Work Order ID 105209

Item Name: Crosstube Turning Detail

DART AEROSPACE LTD		Work Order:	105709
Description: Crosstube Assembly (205/212/412 High Fwd)		Part Number:	D212-664-141
Inspection Dwg: D212-664-141 Rev: D		Page 1 of 2

DRAWING NO. D212-664-141	TITLE XTUBE ASSY (205/212/412 HI FWD)	REV. D	DART AEROSPACE LTD ENGINEERING ORDER		D.E.O. NO. D212-664-141-D-1	SHEET NO SHEET 1 OF 2	SCALE NTS
DRAWN	CHECKED	AP	MFG. APPR.	AP	APPROVED	DE APPR.	
DATE 11.04.07	DATE 11.07.11		DATE 11.04.12		DATE 11/04/12	DATE 11.04.12

**D212-664-141/-141B
ASSEMBLY DETAIL**

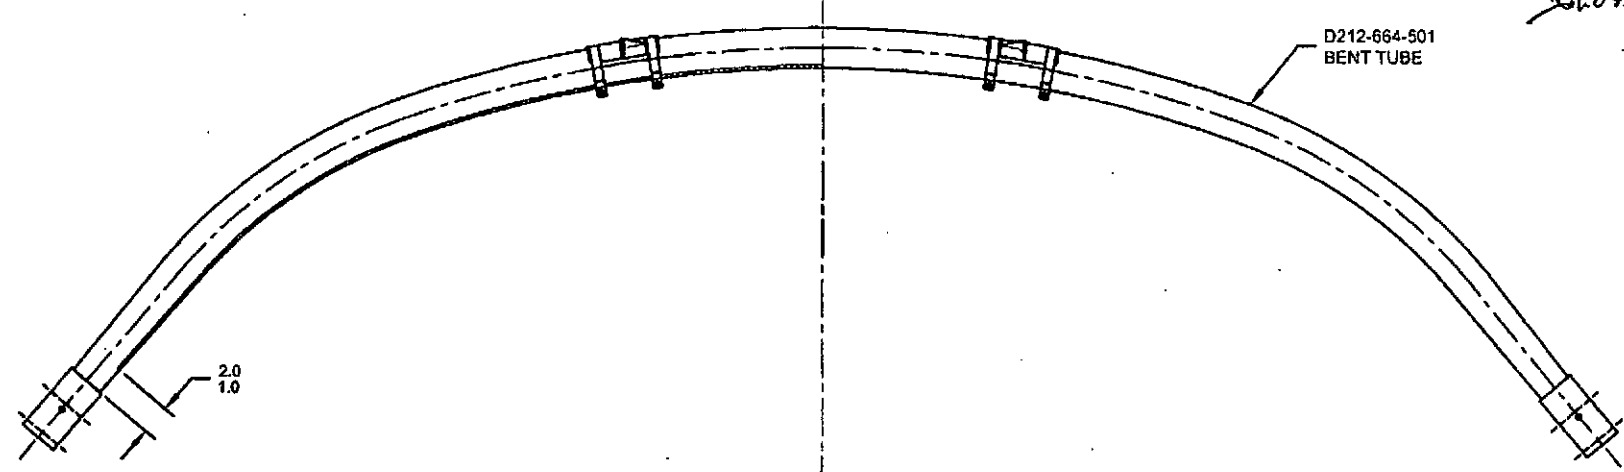
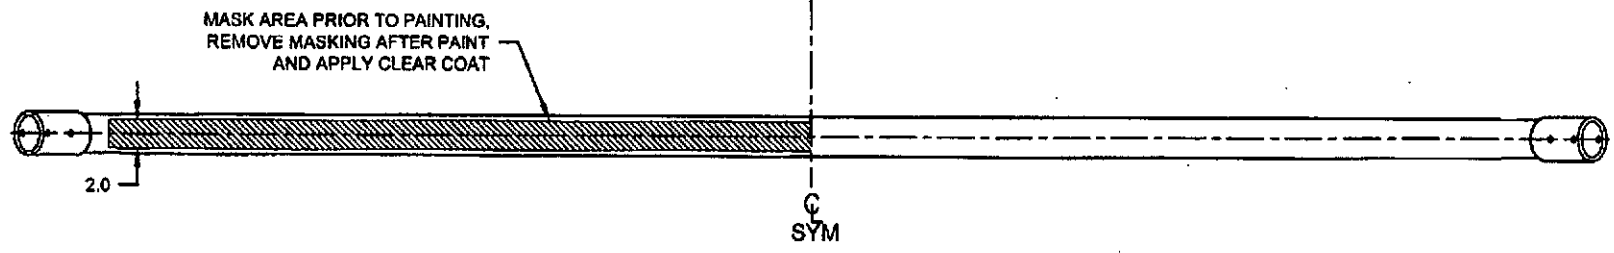
ADD AN INSPECTION WINDOW TO UNDERSIDE OF CROSSTUBE.

NOTES 2 OF SHEET 1 IS AMENDED AS FOLLOWS:

- 2) FINISH: CHEMICAL CONVERSION COAT PER DART QSI 005 4.1
PRIME INSIDE AND OUTSIDE PER DART QSI 005 4.2
MASK UNDERSIDE OF CROSSTUBE AS SHOWN (HATCHED AREA) AND
PAINT OUTSIDE PER DART QSI 005 4.2
REMOVE MASKING AND APPLY CLEAR COAT
